**METROPOLITAN GOVERNMENT OF NASHVILLE AND DAVIDSON COUNTY**

**STAFF RECOMMENDATION**  
**1512 Beechwood Avenue**  
**January 18, 2012**

**Application:** New Construction – accessory structure  
**District:** Belmont-Hillsboro Neighborhood Conservation Zoning Overlay  
**Council District:** 18  
**Map and Parcel Number:** 10416039600  
**Applicant:** Charles Kincaid, Owner  
**Project Lead:** Sean Alexander, sean.alexander@nashville.gov

**A1**

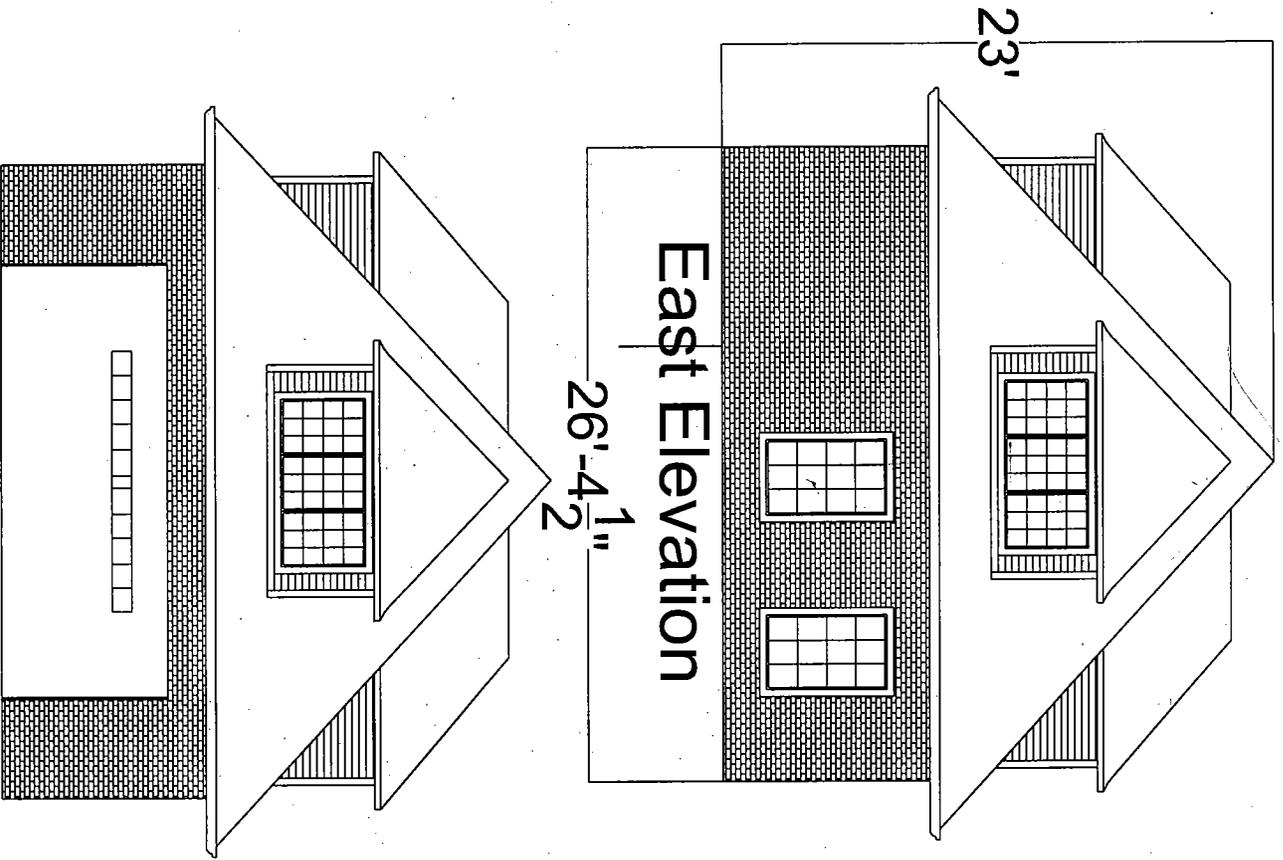
The structure will be located at the rear of the lot, set in four feet (4') from the rear property line and three feet (3') from the right side property line. The garage will have vehicle doors on the left side, facing into the interior of the lot. This location is appropriate for accessory structures, and meets the standard zoning setback requirements and guidelines II.B.1.c and II.B.1.i.2 (Setback and Rhythm of Spacing, Outbuildings). The orientation is also compatible with several surrounding historic structures, meeting guideline II.B.1.f (Orientation).

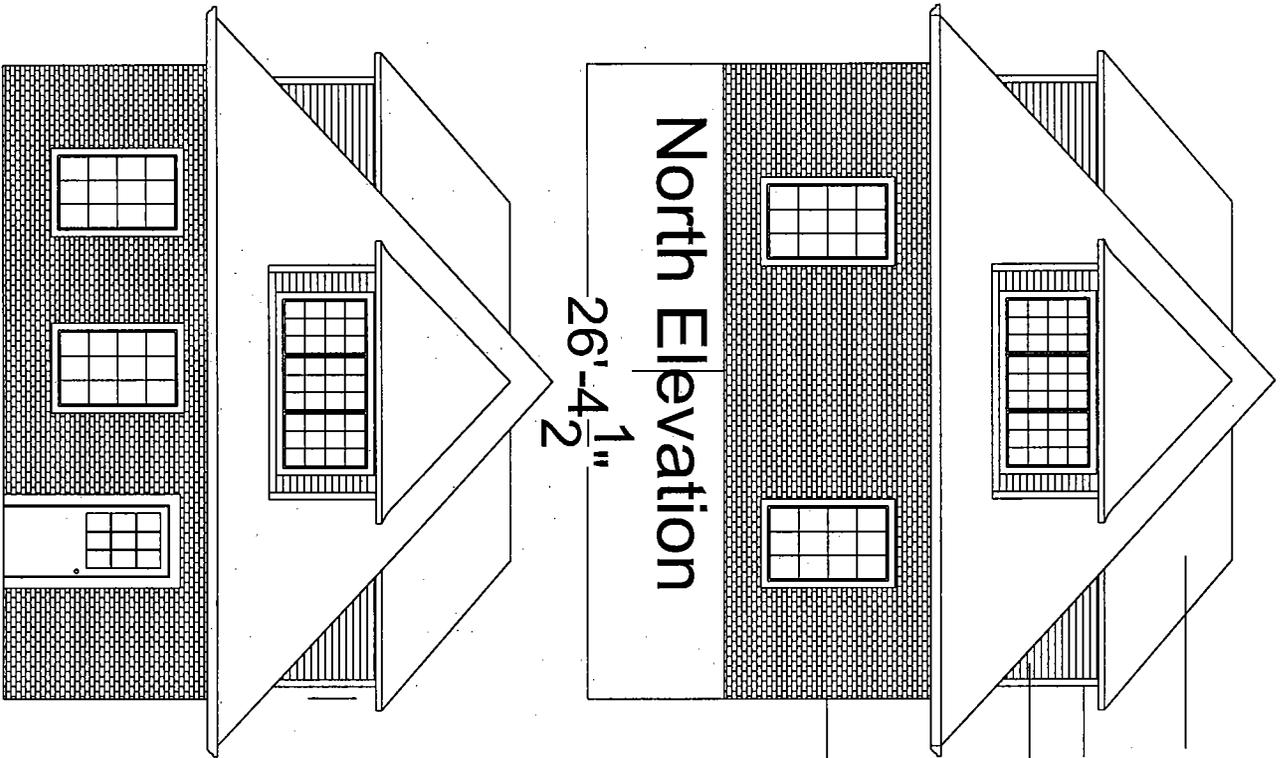
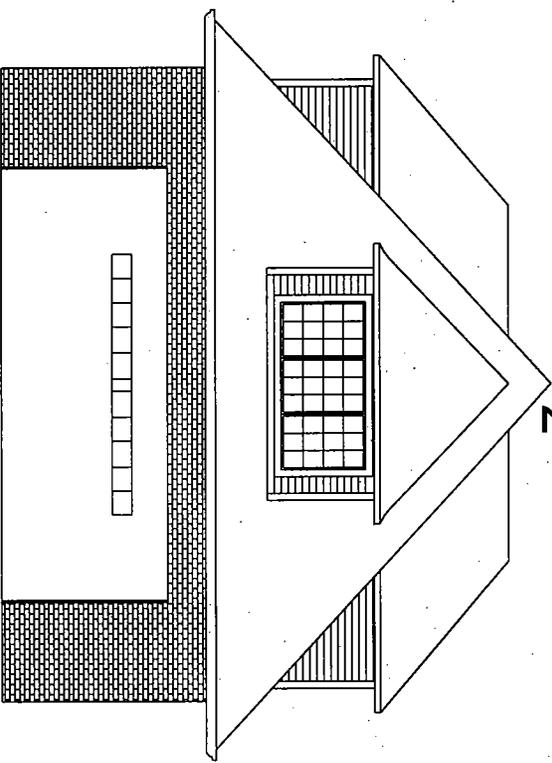
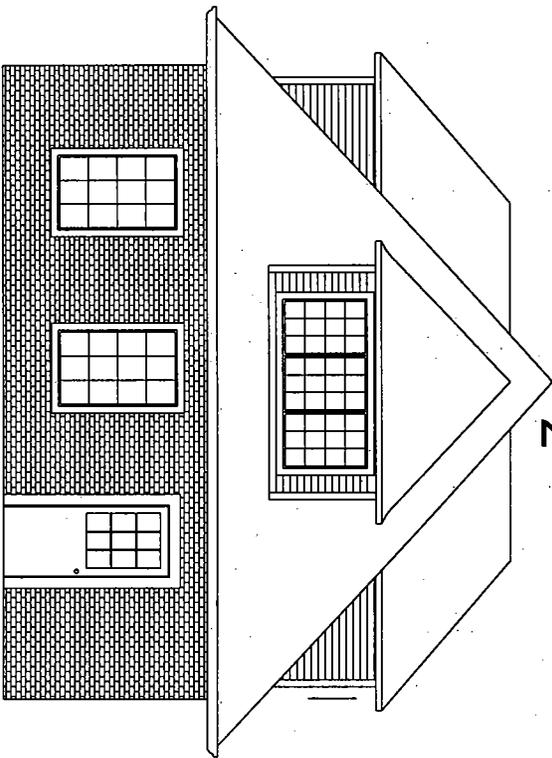
The submitted drawings do not show the structure as having window sills or mullions, and are unclear on the types of vehicular and pedestrian doors and window molding (brick mold is appropriate, flat casing is not). This information needs to be supplied before a permit can be issued. Additionally, the material of any visible foundation will need to be approved.

Generally, the window pattern depicted on the submitted elevations is appropriate, but the proportions of the windows specified do not match the window sizes on the drawings. This discrepancy makes it difficult to determine what the actual proportion and rhythm of openings will be, and if they meet the guideline II.B.1.d (Proportion and Rhythm of Openings). Staff recommends final approval of windows before they are purchased.

1. A brick sample shall be provided to staff for approval.
2. Material of any visible foundation shall be approved by staff
3. Additional detail on the window and door trim shall be provided.
4. The windows shall be an appropriate material, to be approved by staff.
5. The drawings shall show the accurate door and window sizes and locations.
